RE: PLUS 2011-10-03 Response Letter  
**POLYTECH HIGH SCHOOL**  
Woodside, Delaware  
2011081.00

Below you will find the required response to your PLUS comment letter dated November 18, 2011 in reference to expansion of the Polytech High School located on Walnut Shade Road, east of Woodside. Each State comment is listed with the associated response in italics below.

Polytech High School (PLUS 2011-10-03)

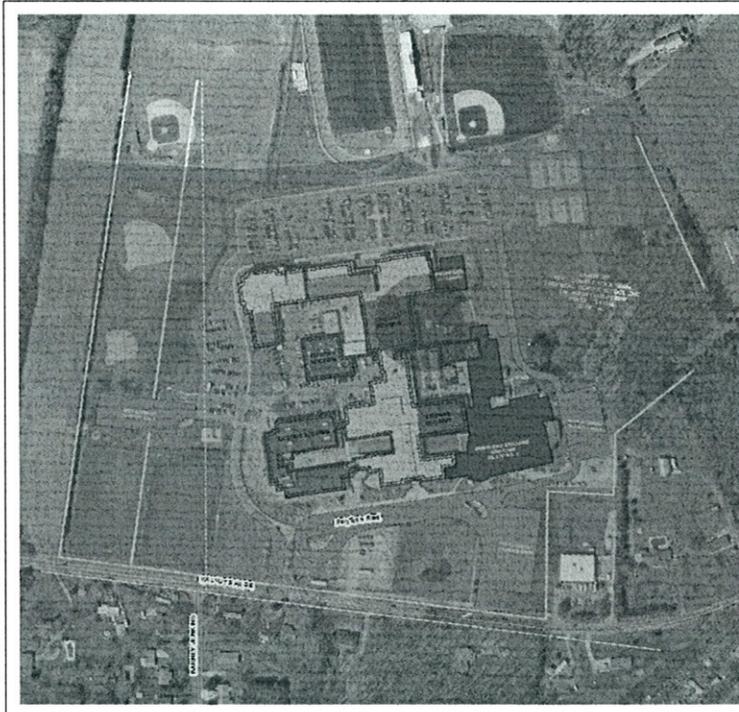
The DNREC Water Supply Section has determined that the project falls partially within a wellhead protection area for Polytech High School and fully within an excellent ground-water recharge potential area for Kent County (see map).

In addition, because the wellhead protection area is the source of public drinking water for Polytech High School and the excellent ground-water recharge area so readily affects the underlying aquifer, the storage of hazardous substances or wastes should not be allowed within these areas unless specific approval is obtained from the relevant state, federal, or local program.

- Keep impervious cover to less than 50%
- Perform an environmental assessment report showing that *water quality* as well as *water quantity* of post development recharge is equal to or greater than pre-development recharge (Kaufmann, 2005).
- Quantify amount of recharge lost due to impervious cover and provide for onsite infiltration of water at least equal to or greater than pre-development recharge (Kaufmann, 2005).
- Pretreatment of parking area runoff to remove dissolved chemical and nutrient loads prior to infiltration
- Use Better Management Practices in the design, construction, and maintenance of a stormwater management system designed to address water quality with respect to nutrient and other pollutant loads.

In addition, because the excellent ground water recharge area can readily affect the underlying aquifer if contaminants are spilled or discharged across the area, the storage of hazardous substances or wastes should not be allowed within the area unless specific approval is obtained from the relevant state, federal, or local program.

***Response:*** Kent County zoning for this site allows a maximum impervious coverage of 30%. Soil borings and infiltration tests are being performed to determine infiltration rates. Infiltration will be considered depending on the rates determined from the field and laboratory tests.
